Private Fuel Storage, LLC

**RESPONSE TO EIS REQUEST FOR ADDITIONAL INFORMATION
PRIVATE FUEL STORAGE FACILITY
DOCKET NO. 72-22 / TAC NO. L22462
PRIVATE FUEL STORAGE L.L.C.**

Reference: 1) NRC Letter, Young to Parkyn, Request for Additional Information,
dated December 18, 1998

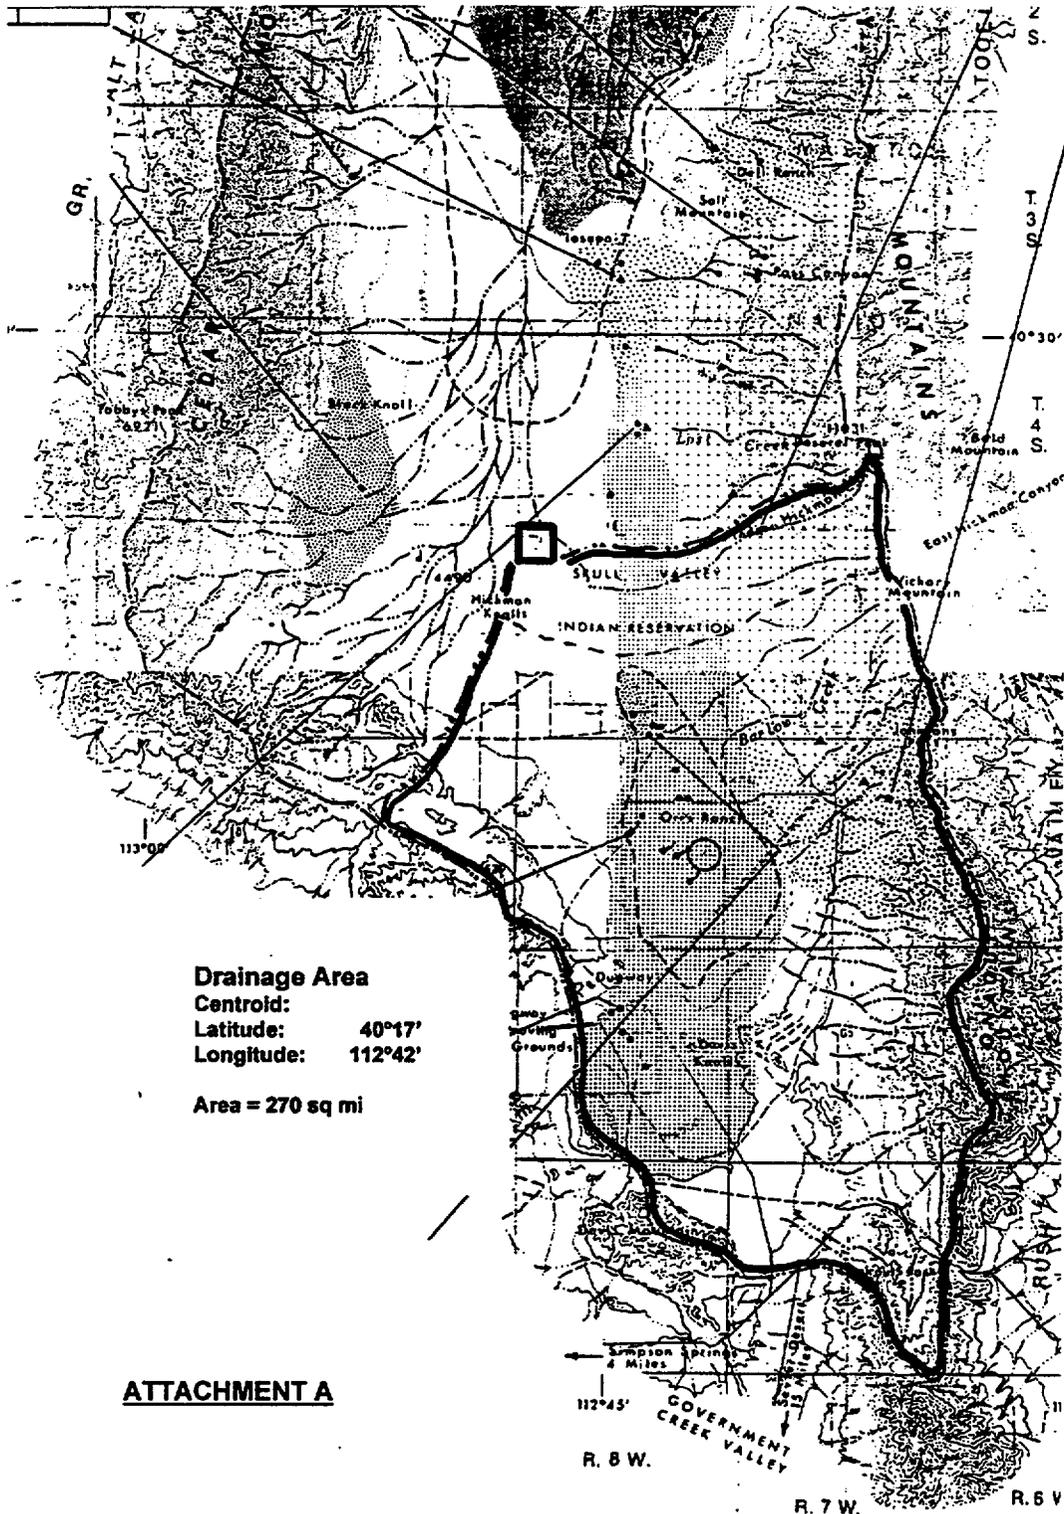
- 8-3 a. Explain why the probable maximum flood (PMF) calculation in the license application identifies a drainage area of 26 miles, rather than a larger area (e.g., 240 square miles) and discuss the potential effects of runoff.
- b. Indicate where the proposed natural drainage system is located.
- c. Provide the basis for the statement on page 4.5-1 that localized aquifer drawdown from facility water use "is not expected to have any effects on adjacent water users."

In response to the question above, the flooding calculation and reference maps were reviewed to confirm the size and configuration of the drainage basins. Since the observed saddle is not clearly distinguishable on the USGS topographic maps, the analysis was redone to include a larger and more conservative drainage area.

In conclusion, considering the larger and more conservative drainage basin of 270 square miles, the predicted water levels for both the 100-year flood and PMF are still below the site elevation and the site is not subject to flooding.

The calculated flows have increased due to the larger area, but not proportionally. The Q_{100} has increased from 2,247 cfs (Reference 1) to 2,430 cfs and the Q_{pmf} has increased from 34,577 cfs (Reference 1) to 53,000 cfs. These new and higher values can and will be accommodated in the design of the access road. It should be noted the design of the access road includes providing culverts to pass the Q_{100} beneath the road, whereas the Q_{pmf} would overtop the road surface.
